Attachment No. 2
Revised set of Plans

IDALS CAL883432B NUTRIENT REDUCTION WETLAND

CONSTRUCTION PLANS

ISG PROJECT # 24-30402

C3-10

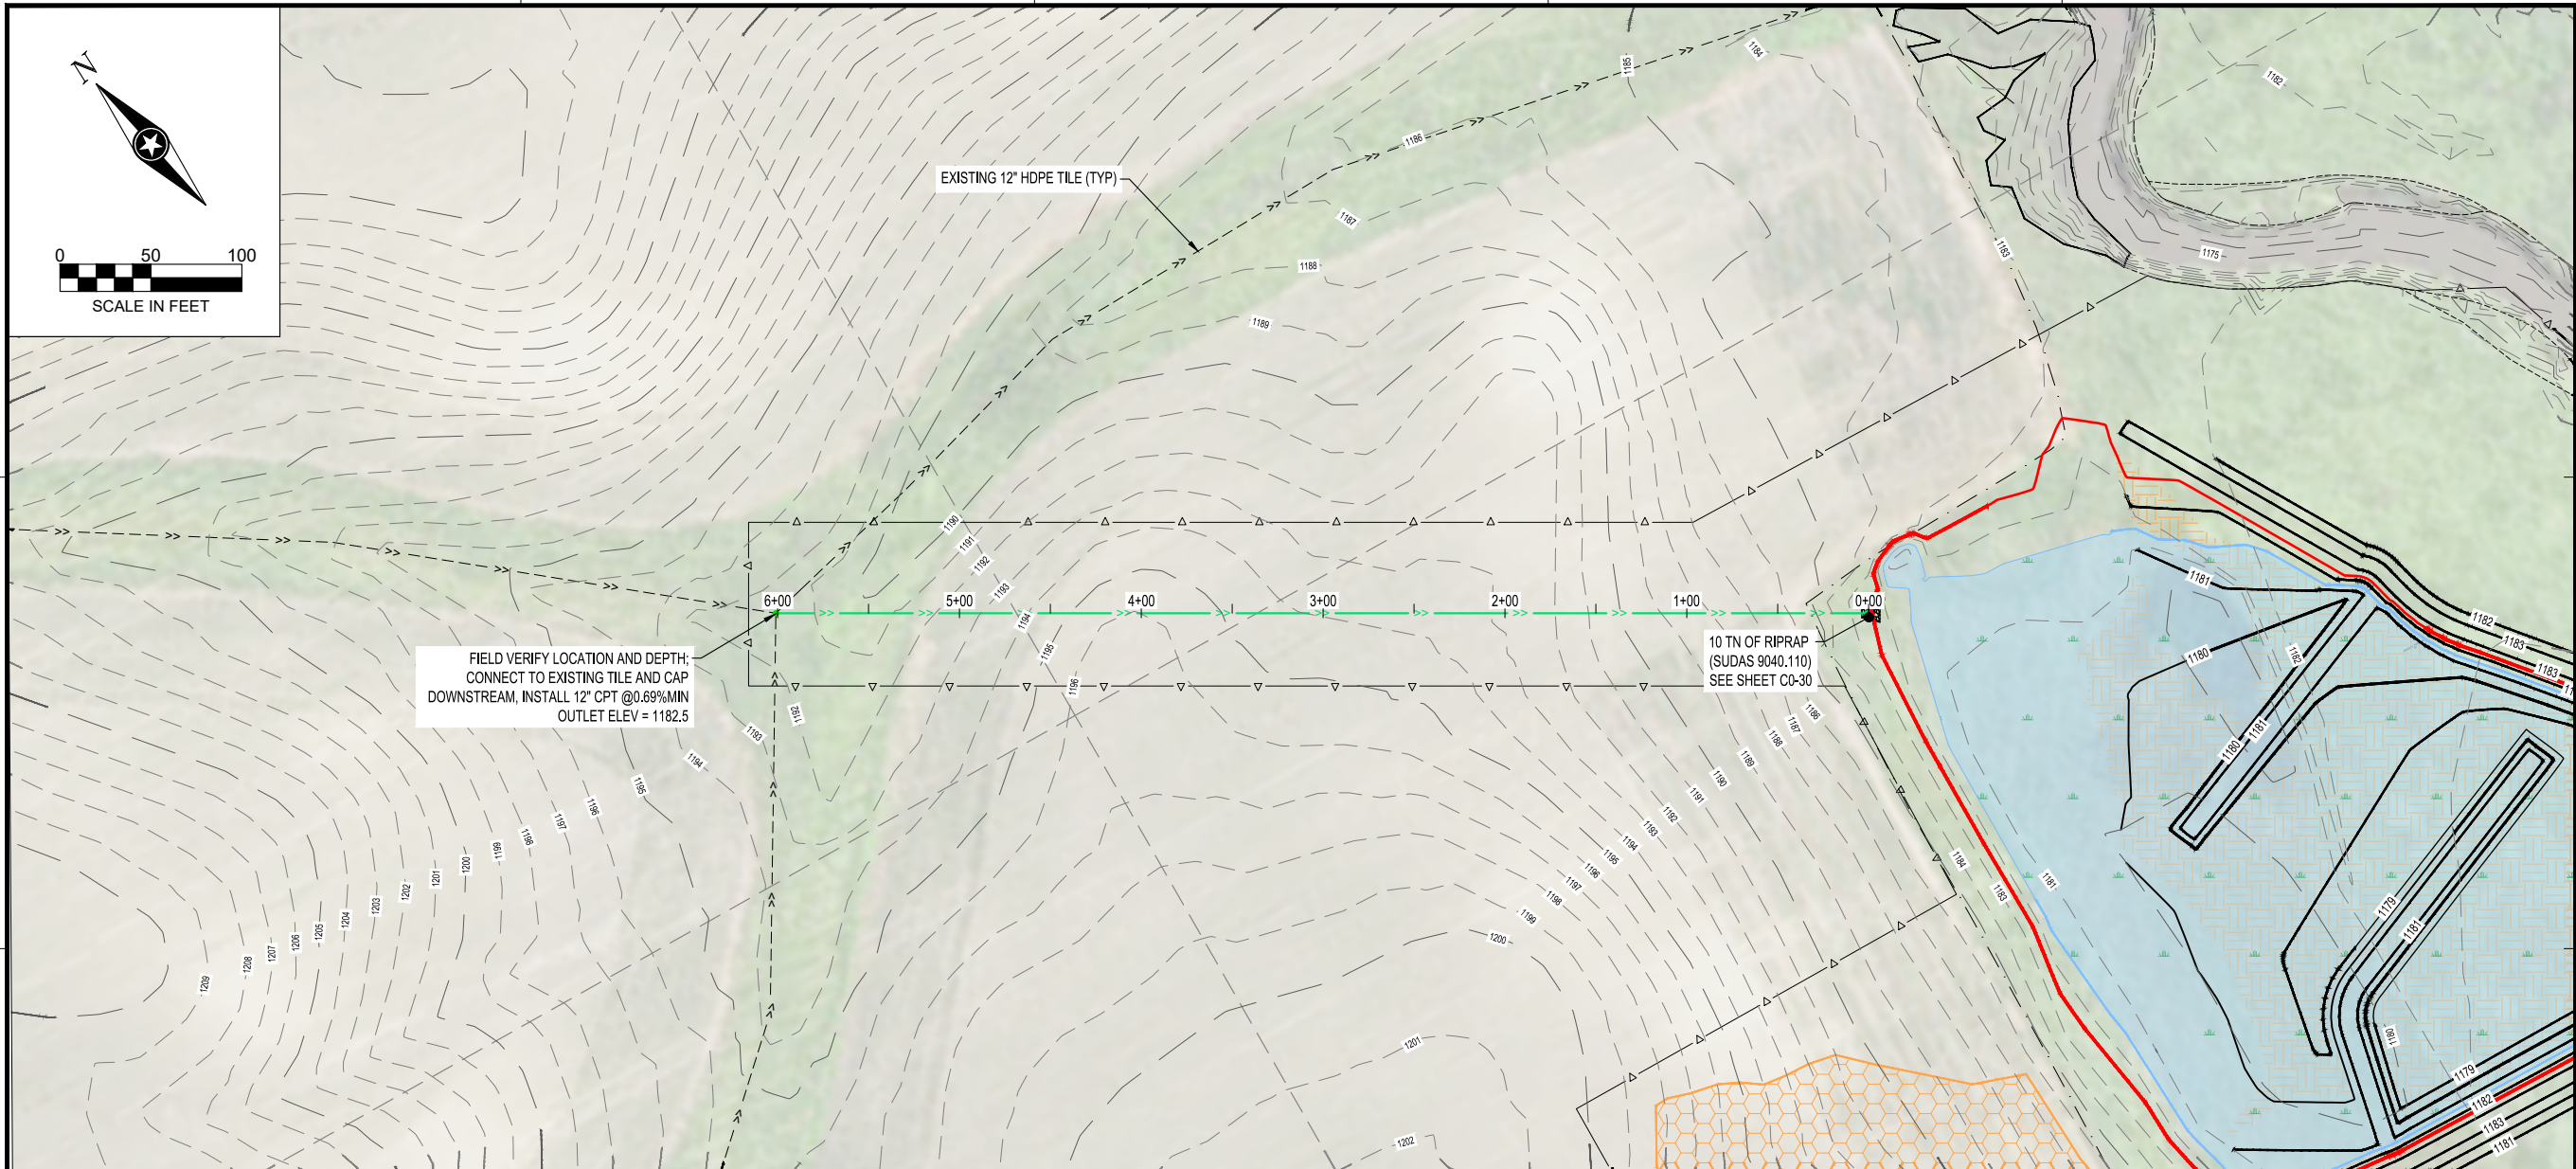
REVISION SCHEDULE		
DATE	DESCRIPTION	BY
8-13-2026	CORRECTED EASEMENT ANNOTATION SITE CHARACTERISTIC TABLE VALUE	HLC

SHEET
C3-21

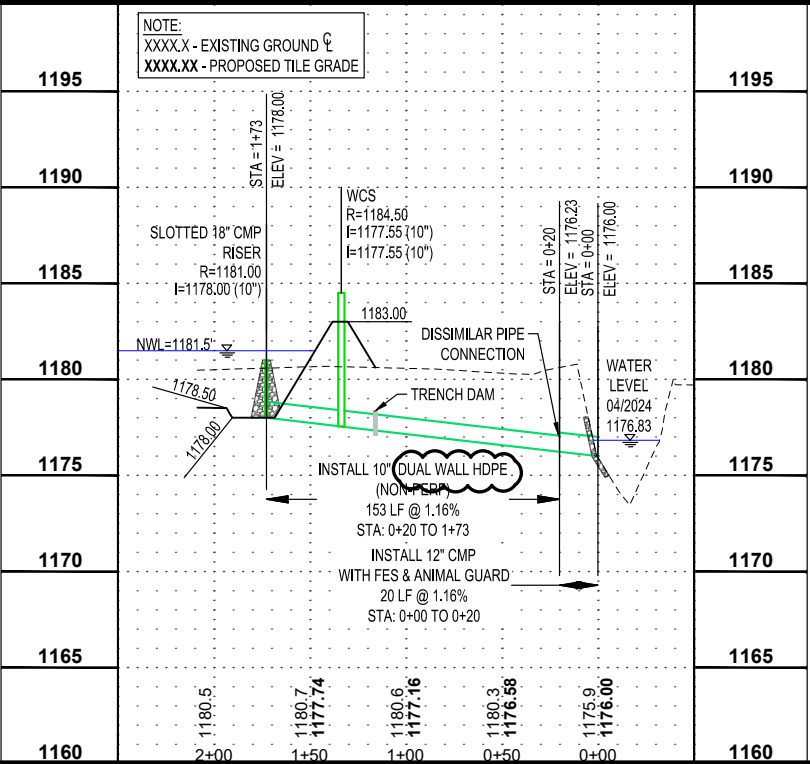
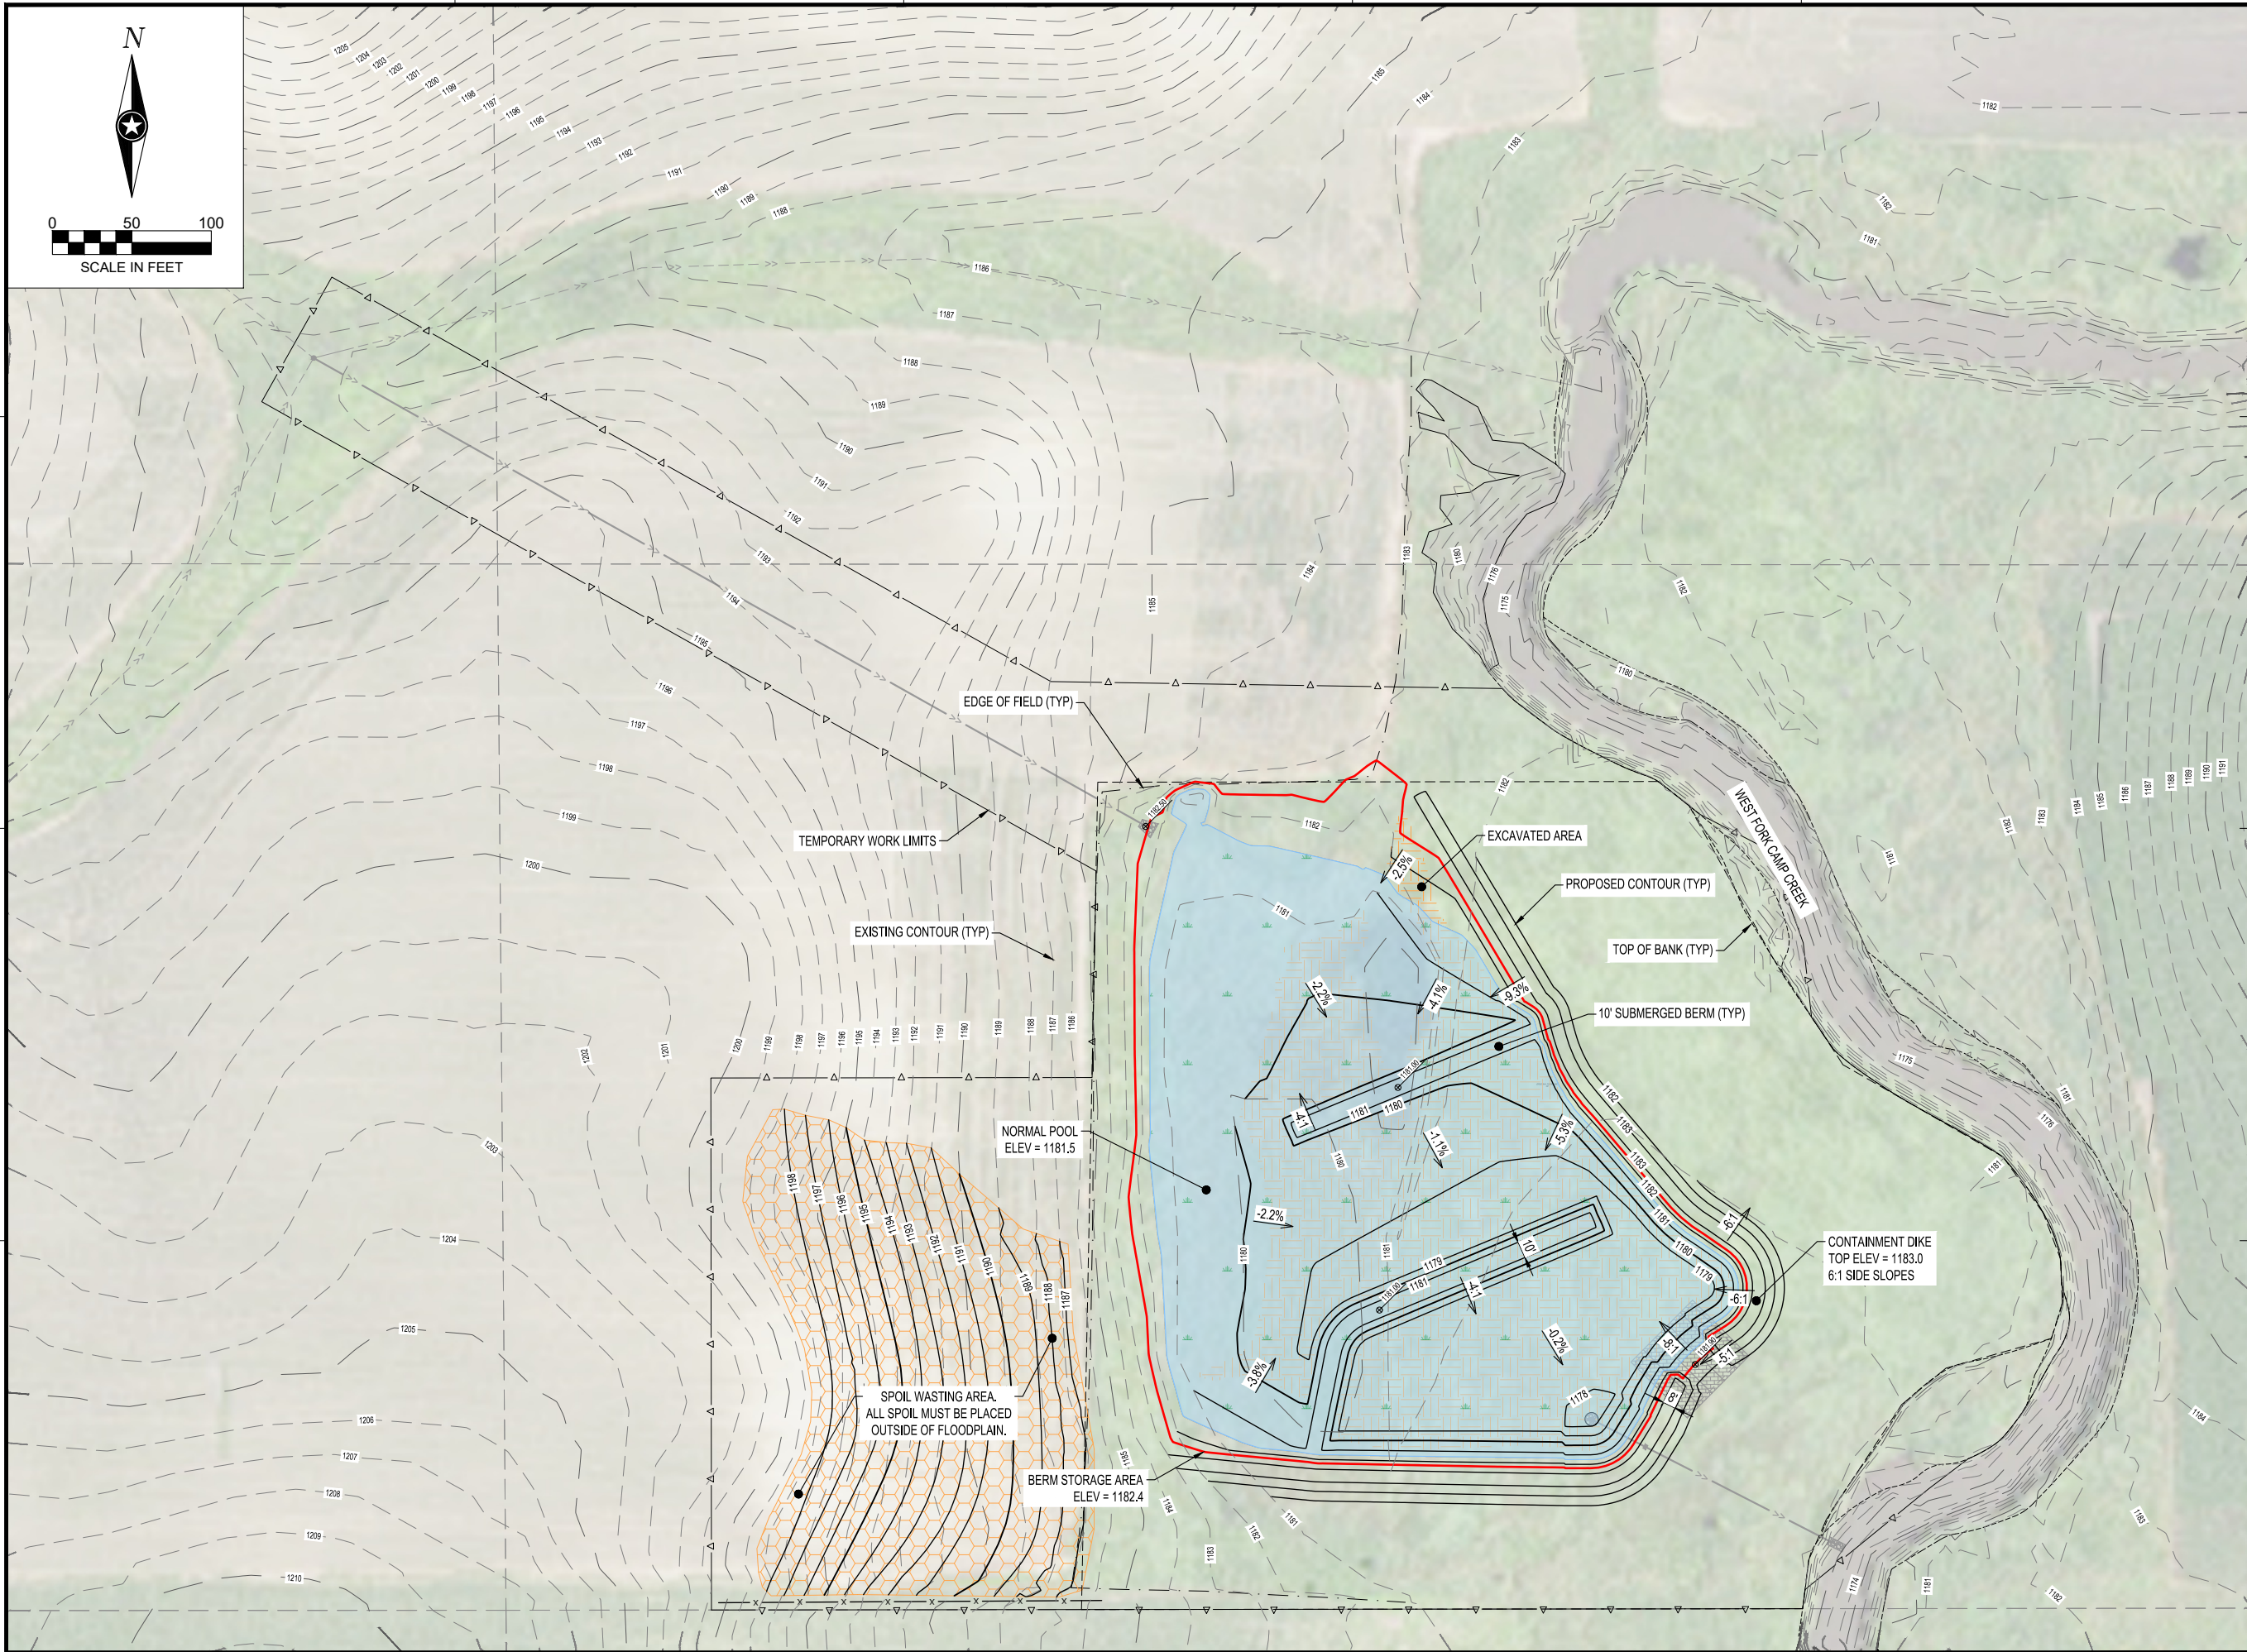
REVISION SCHEDULE		
DATE	DESCRIPTION	BY
8-13-2026	CORRECTED PIPE TO "DUAL WALLED"	HLC
